SUTHERLAND SHIRE COUNCIL ASSESSMENT REPORT

Panel Reference	PPSSSH-131
DA Number	MA23/0006
LGA	Sutherland Shire
Proposed Development:	S4.55(2) Modification to DA21/0562 - Changes to development description, add hours of operation for a supermarket, delete design change conditions 2i), 2ii), 2iii) and 2iv), amend condition 37, and 44 and internal layout changes
Street Address:	3 - 23 Kingsway CRONULLA Lot 61 DP 319303, Lot 13 DP 205207, Lot 14 DP 205207, Lot 15 DP 205207, Lot A DP 314601, Lot B DP 314601, Lot 1 DP 5239, Lot 1 DP 700935, Lot 2 DP 700935, Lot 1 DP 1004748
Applicant/Owner:	CCIG Pty Ltd Helen Karageorge, Paul Milsted, Concetta Sorbara, Antoinetta Palumbo, Sam's Food Bar Pty Ltd, John Palumbo, Jenell A Milsted, CCIG Pty Ltd
Date of MA lodgement	3 February 2023
Number of Submissions:	6
Recommendation:	<i>Approval</i>
Regional Development Criteria	<p>The original application DA21/0562 was referred to the SSPP as it had capital investment value of more than \$30 million and is identified as Regionally significant development under clause (2) of Schedule 6 of State Environmental Planning Policy (Planning Systems) 2021.</p> <p>This s.4.55(2) modification application is referr

Figure 3: Original Ground Floor Plan and area excluded from GFA calculation

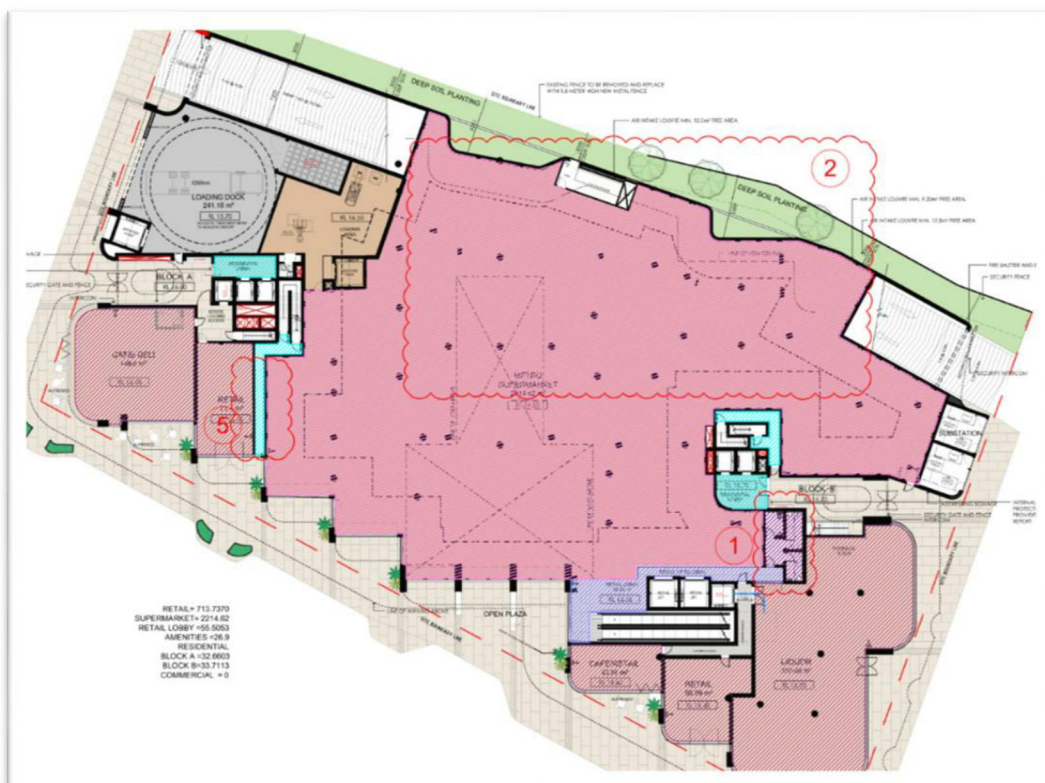
The application proposes an increase to the gross floor area of the development as a result of internal layout changes to the ground floor. A significant quantum of floor space was excluded in the original Development Application as back of house loading / plant services adjoining the supermarket. The proposal retains a loading area adjacent to the loading dock / service lift and along with back of house / storage on Level 1. The approved GFA for the development is 15,670.1m² (3:1) and the proposed increase in GFA is 16,059.71m² (3.07:1 / 2.49%). Below is an extract of the GFA calculation plans of the ground floor detailing the increase in supermarket floor area and reduction in the back of house loading / plant services (refer **Figures 3 and 4**).

An assessment of the proposal against the objectives of the building density development standard has been undertaken and the modified development is considered to be acceptable. The increase in GFA is located wholly within the approved building envelope and does not result in any changes to the bulk or scale or external visual appearance of the development. The loading dock continues to comply

Figure 5: Approved balcony depth Apartment A8.01

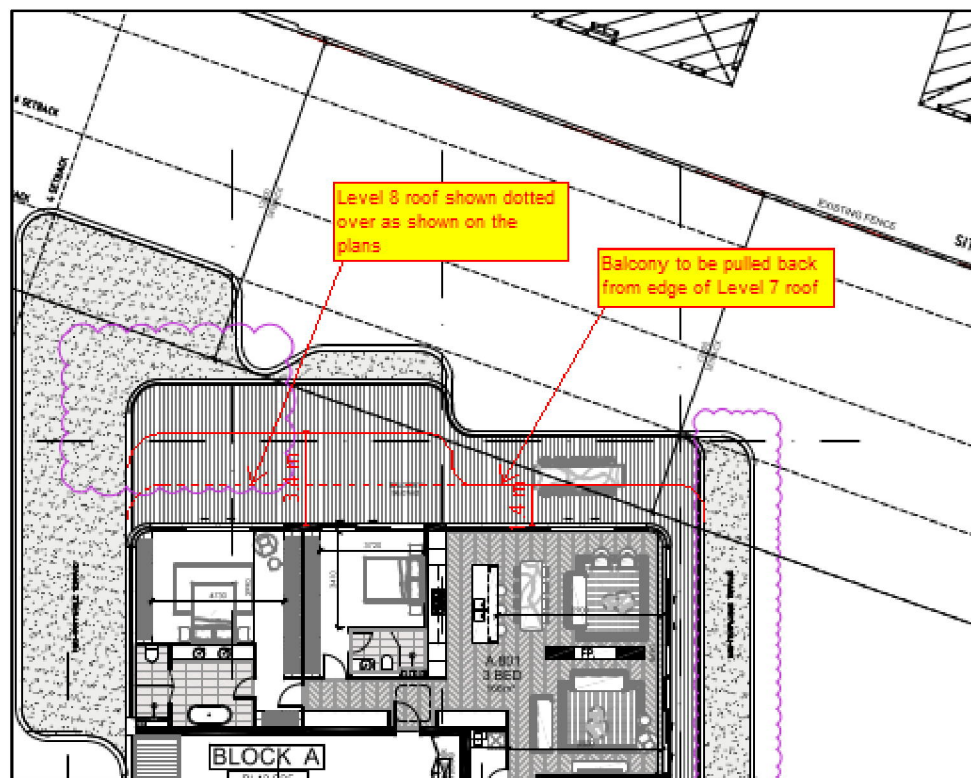
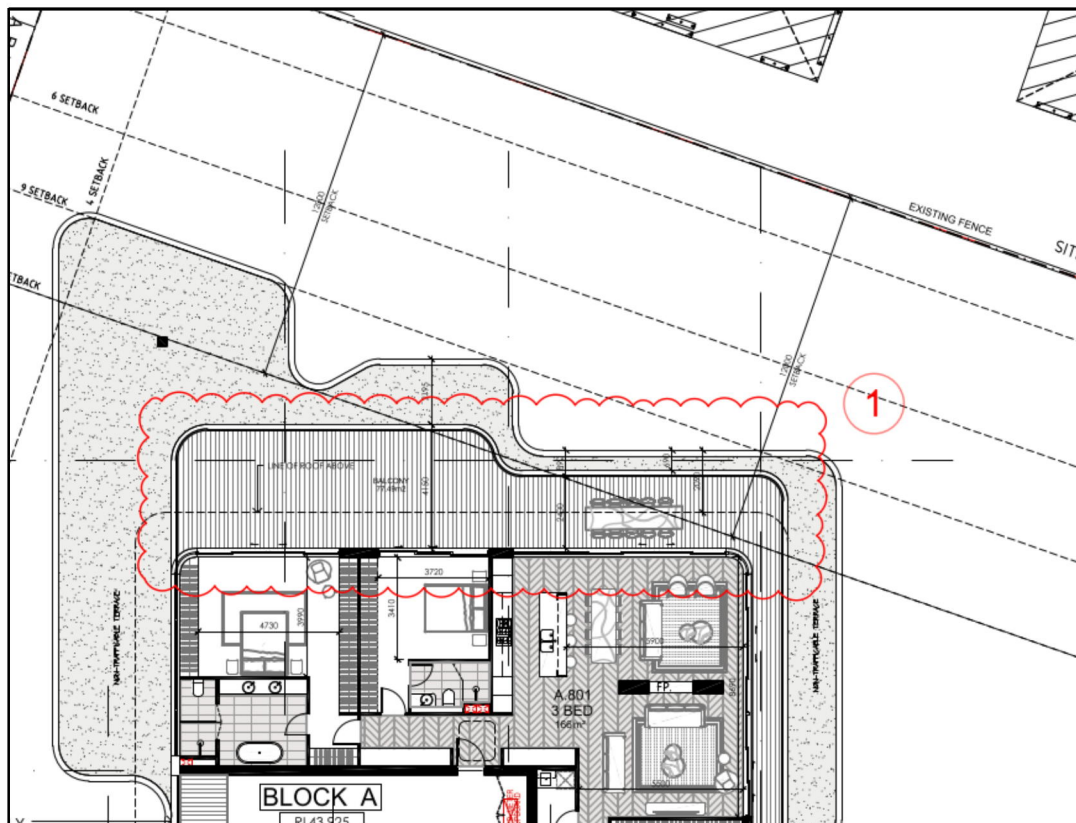
As Levels 7 – 8 are over 25m in height, the required setback is 15m from the northern boundary in accordance with the ADG (i.e. 12m + 3m zone boundary setback for habitable spaces) and the above conditions were originally imposed to maximise this setback and to improve the visual relationship / privacy between properties. In the original determination commentary, the SSPP noted that:

The scaling back of the built form at the upper level to the northern boundary (i.e. increased setbacks to the trafficable balcony / balustrade edge of Apartments A8.01 and B8.01. / B8.02) is required to be provided to a reasonable degree to remain consistent with the relevant objectives / ADG requirements. The extent of the condition does however present a function / amenity issue to apartment A8.01 given the 1.4m limited dimension adjacent to the living space (noting 2.4m dimension is required by ADG). In response to concerns raised, the applicant has submitted revised plans whereby a compliant 2.4m depth is provided which enables the balustrade to be setback from the building edge approximately equal to its respective height.

The approach of setting back the balustrade from the building edge in this manner (including when carried also forward of the bedrooms of A8.01 and B8.02) both sufficiently increases the usable external space and serves the intent of scaling back the upper level built form encroaching within the ADG setback requirement improving both the amenity and the visual interface with the adjoining R3 – High Density Residential Lands. The reinstatement of the eave adjacent to apartment B8.02 is complimentary to the visual appearance and aesthetic of the development, and in the absence of any significant impact, is considered to be acceptable.

In summary, the relevant urban design matters contained within SEPP 65, the ADG, Clauses 6.16 and 6.17 of SSLEP 2015 and SSDCP2015 have been considered in the assessment of the application. The revised plans submitted by the applicant are considered to be acceptable and the Conditions 2A(i) and (ii) are recommended to be deleted.

Figure 11: Proposed location of awning indents along Kingsway and Croyden Street.

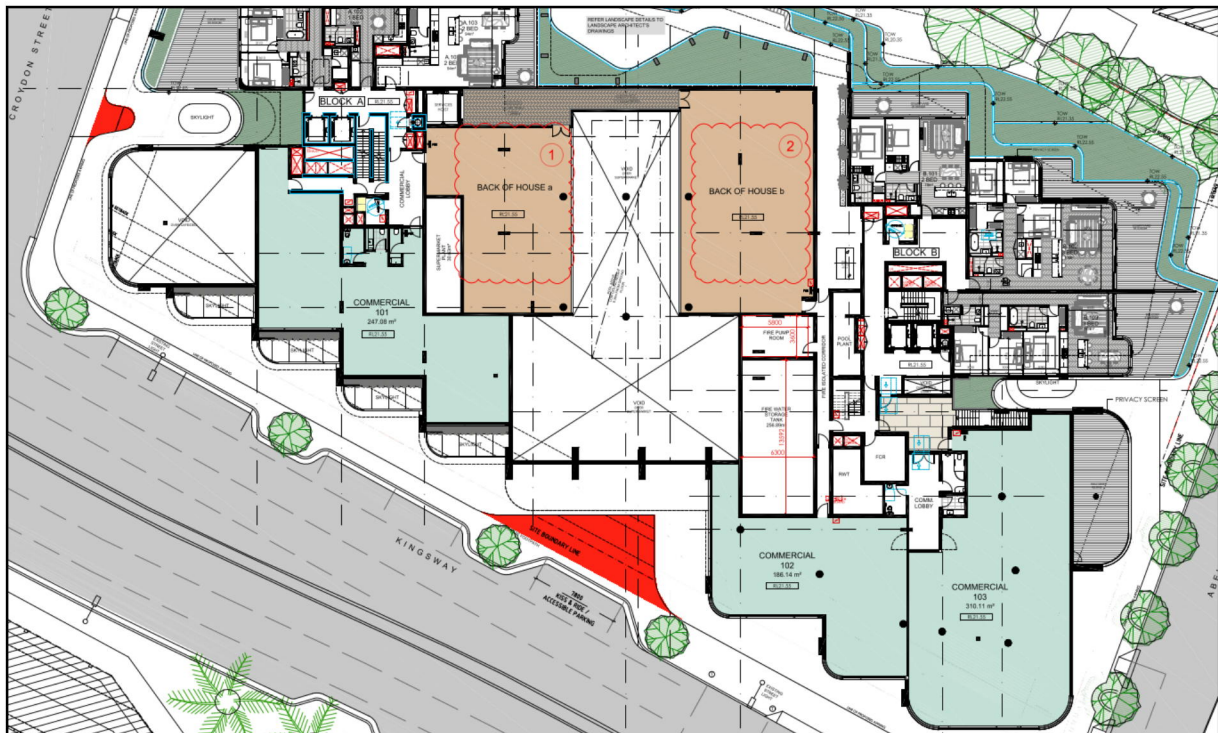
The application seeks to delete Condition 2A(iii) of the Development Consent which requires a continuous awning along the Kingsway and Croydon Street to provide continuous pedestrian shelter

over the width of the footpath and aligned with the kerb. This is primarily to maintain the indents at entry points, which whilst defines the entries from a wayfinding perspective and is complementary of the overall aesthetic / composition of the development, fails to provide an appropriate outcome for the public within the public domain. The indents to the awning are depicted in **Figure 11** below.

Consistent with the condition of consent and Chapter 19, 11.2.6 of SSDCP 2015 which requires continuous awnings to be provided along shop fronts and active street frontages, Council's Public Domain team have confirmed the requirement for a continuous awning for all weather pedestrian protection over the public footpath. The design details of the condition have been further reviewed however and a revised design specified to ensure an appropriate outcome in the public domain and to ensure adequate room for the future plantings of *Araucaria columnaris* 'Cook Pines' along the Kingsway. The design is described and depicted in Council's diagram below (refer **Figure 12**), noting that indents to the awning are not supported and this remains a matter of contention in the assessment of the application.

Figure 13: Revised location and design of sanitary facilities

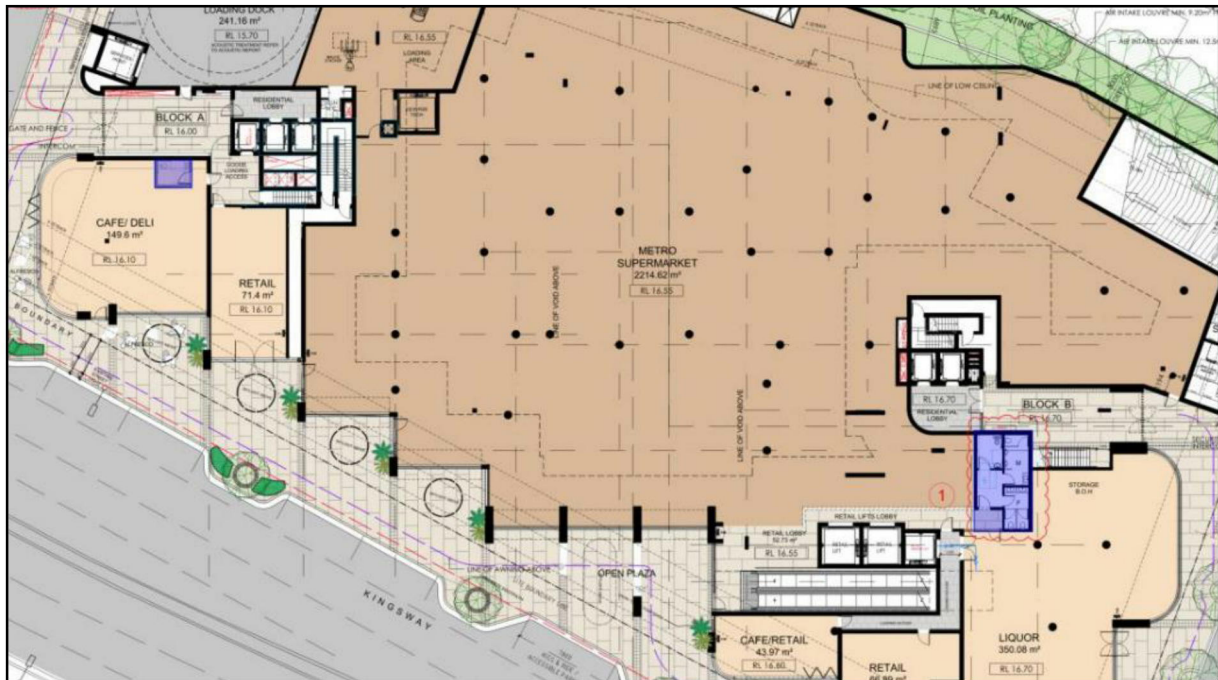
Condition 2A iv) of the Development Consent requires public amenities are to be provided on the ground floor to serve the general public and retail commercial tenancies. The revised ground floor plan (refer **Figure 13**) details sanitary facilities to the ground floor of the development consistent with the terms of the approval. Following a request, a comprehensive breakdown of occupant numbers by a suitably qualified building surveyor and demonstration of compliance with the BCA has been submitted. This has been reviewed by Council and is acceptable. The condition of development consent is recommended to be imposed requiring sanitary facilities to be adjusted in line with the consultants' diagram / recommendations.
